CITY PLANNING COMMISSION

- APPLICATION:
1. Negative Declaration
  2. Variance to locate 13 parking spaces required in connection with expansion of an existing mortuary off-site on a vacant General Commercial (C-2) lot, 0.13 ac. in size.
  3. Lot Line Adjustment to merge two existing parcels

LOCATION: Northwest corner of 43rd Street and Broadway

P-83-047

LOT NO. 9, 11 and 12 : STRAWBERRY HILL  
SCALE 1/4" = 1'-0"  
LOT LINE ADJUSTMENT

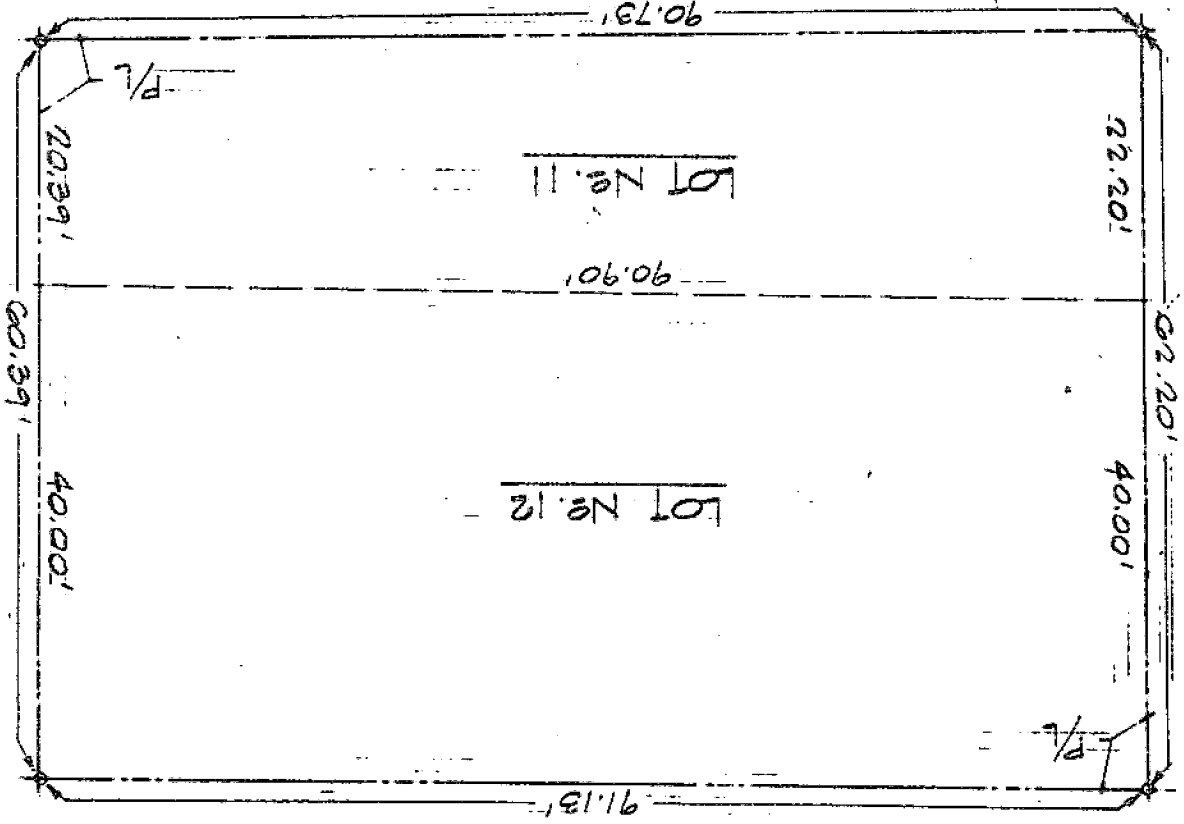
- c. The parking lot should be lighted with the light fixtures directed away from adjacent residential properties to minimize glare problems.
4. The applicant proposes to combine the two vacant parcels in order to develop the subject parking lot. The proposal was reviewed by the offices of the Engineering, Water and Sewer and Planning Departments. There were no objections to the request. Staff recommends approval of the lot line merger with conditions which are stated in the attached resolution.
